Ayrlawn, Limited Preliminary Plan Amendment 12012011A

Staff Report Date: 02-28-14

Amendment: Amendment to modify Condition No. 2
 Location: Located in the northwest quadrant of the intersection of Johnson Avenue and Lindale Drive
 Zone: R-60
 Master Plan: Bethesda/Chevy Chase
 Property size: 0.76 acres
 Applicant: Betty W. Sutermeister Revocable Trust
 Submitted: September 26, 2013

Stump of the unnumbered 17" cedar tree

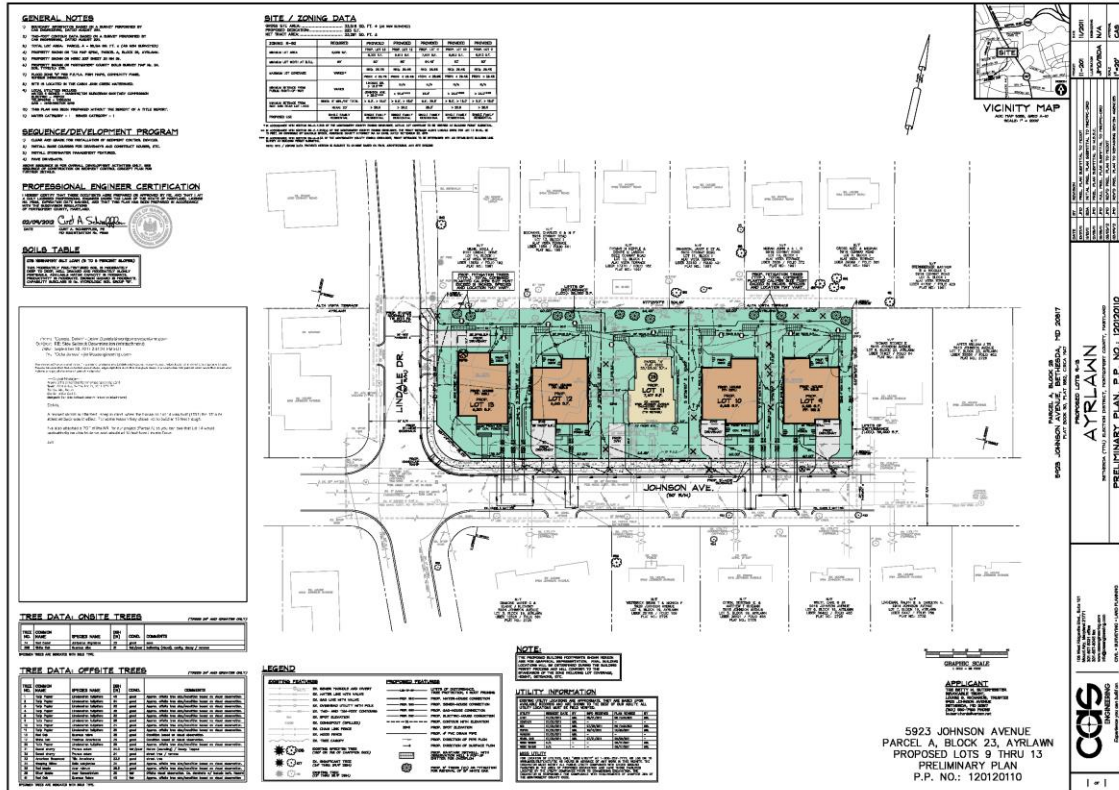
On September 26, 2013 the current amendment which included a revised tree save plan was submitted. The applicant's consultant indicated that one of the trees protected by the Planning Board condition had already been removed from the site. They reported the unnumbered 17" cedar tree was removed from the site (prior to submission of the amendment/tree save plan) in response to a hazardous condition. Staff had requested further information on the circumstances of the tree removal and hoped to receive a more conclusive explanation on the removal.

Staff visited the site to make an assessment of the stump and look for signs of decay or other evidence supporting the owners' claims. However the site visit revealed that the stump had already been ground out.

The applicant states that the tree was previously removed due to its condition and proximity to the existing house. Staff acknowledges that the tree should not have been removed without prior consent from the Planning Board per the conditions of approval. Although the removal is a violation of the conditions of approval, staff does not recommend enforcement action since the currently proposed conditions require appropriate mitigation plantings. The consultant has reported on behalf of the applicant that they agreeable to the additional plantings. Staff also acknowledges that the tree save plan should not have been stamped as "approved" without the ultimate approval by the Planning Board.

The tree save plan will be further revised to show the proposed mitigation plantings for the 17" tree that was removed. The plan will show 3 new replacement trees on Lot 11, with at least one tree planted near the area of the unauthorized removal.
